CITY PLAN COMMISSION STAFF REPORT

CD-CPC-2025-00133

Executive Park Lot 6 Major Amendment

Rezoning to UR - Major Amendment

SHEET TITLE
LIGHTING PLAN

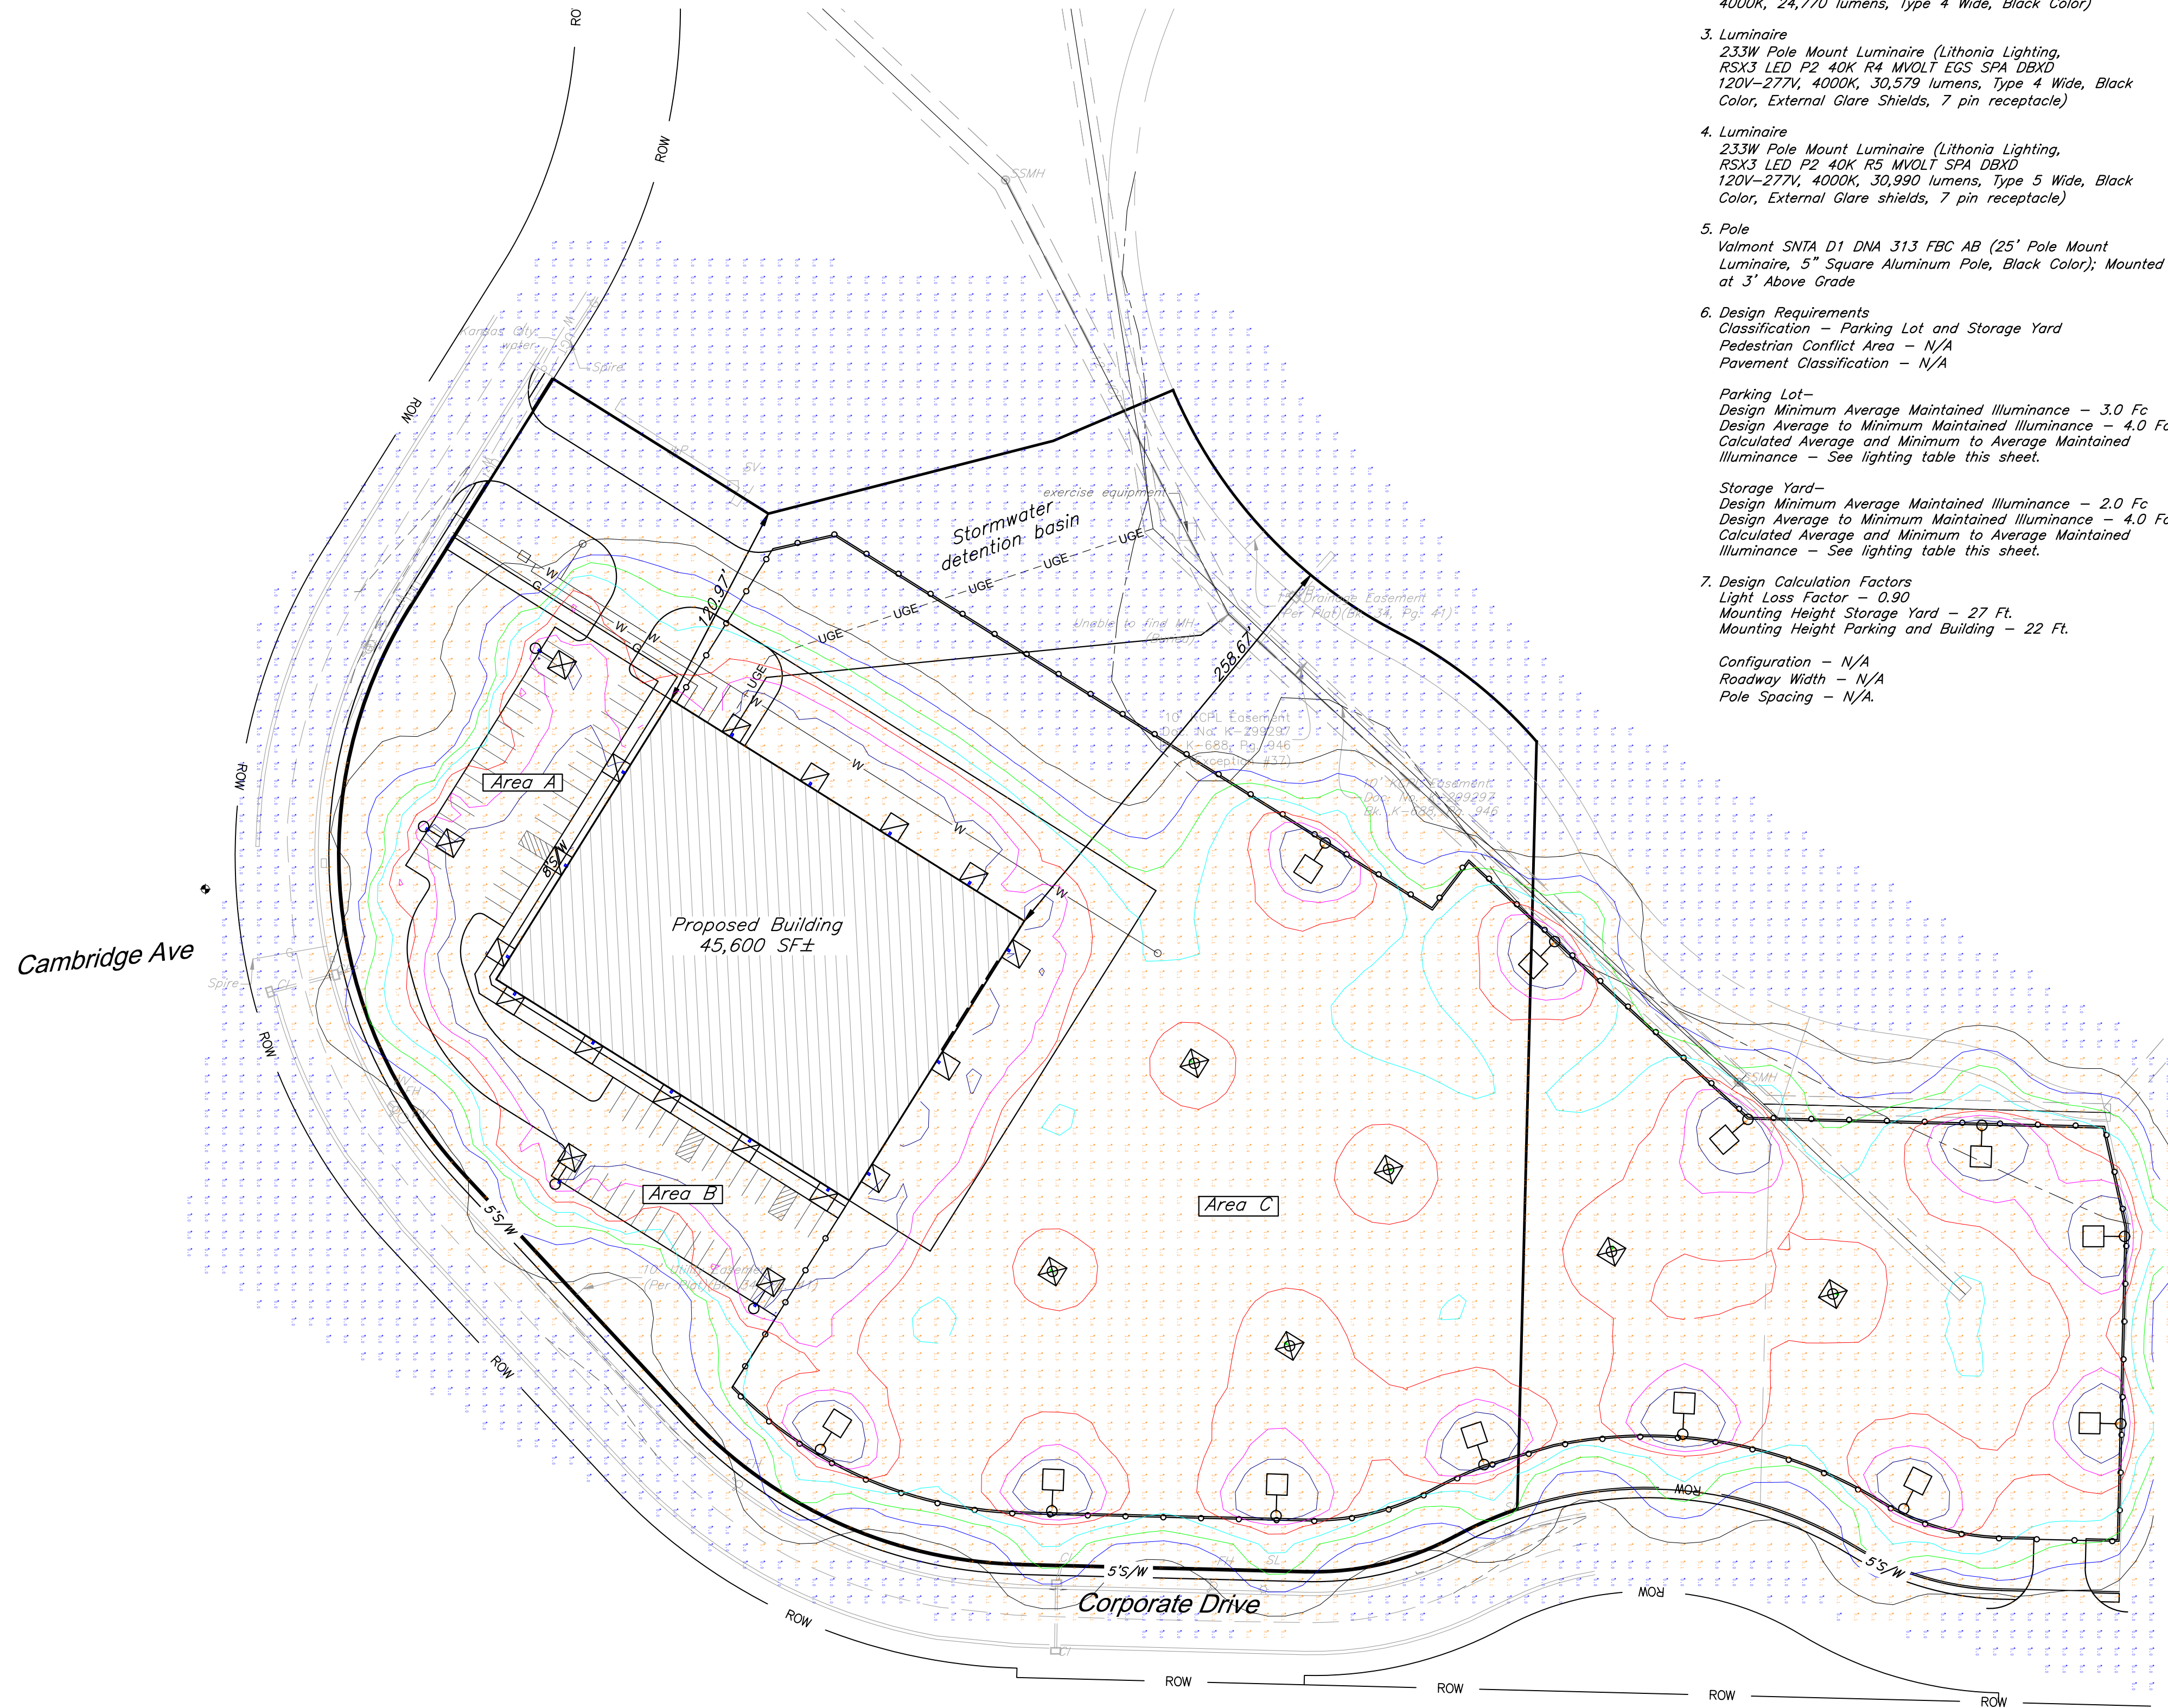
The applicant worked with staff to provide appropriate landscaping throughout the site. The applicant will be required to work with the Police Department prior to ordinance request regarding a remaining correction on the submitted photometric plan.

7. Applicant shall work with the Police Department to complete the corrections below prior to ordinance request:
 1. Need a lighting plan for review per city ordinance 88-430-06-A. The lighting for the location should be in compliance with the Illumination Engineering Society (IES) minimum standards. The parking lot area of truck parking for an industrial site/warehouse should have an average maintained foot-candle (fc) level of 2fc with an average to minimum ratio of 4:1 (G-1-22, Sec. 8.4). The general public parking lots should have an average maintained level of 3fc with an average to minimum ratio of 4:1 (G-1-22, Sec. 8.7)

2. Identify the maximum height of plantings in close proximity to lighting elements. The mature height of these planting shall not impact or lessen the foot-candles shown on the approved photometric plan.

BUILDING ELEVATIONS

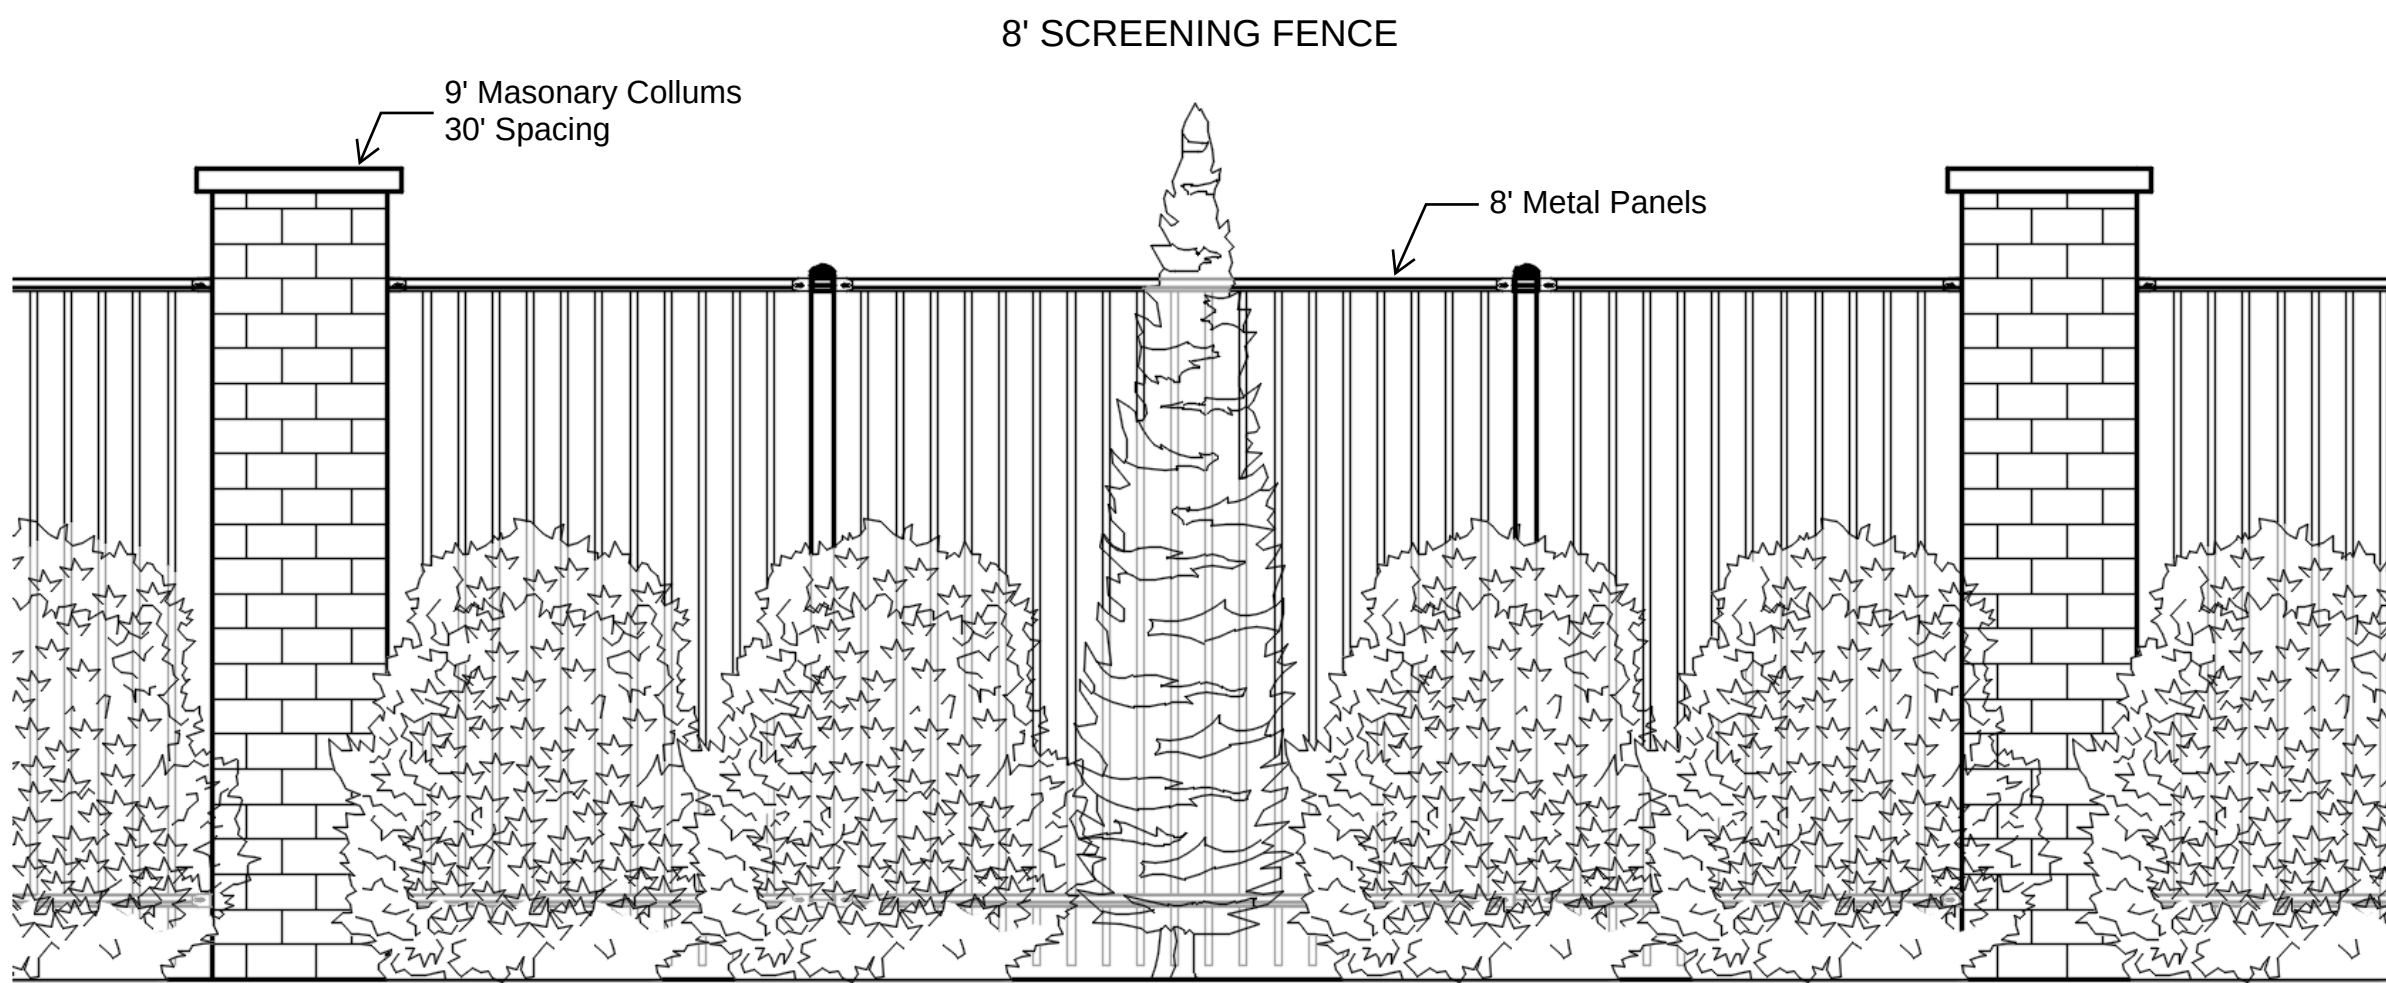
The area the property is located in is mostly developed with larger buildings. The applicant has provided proposed elevations. Staff requested the applicant provide windows along the rear of the building, however the applicant decided to move forward with the elevations submitted.
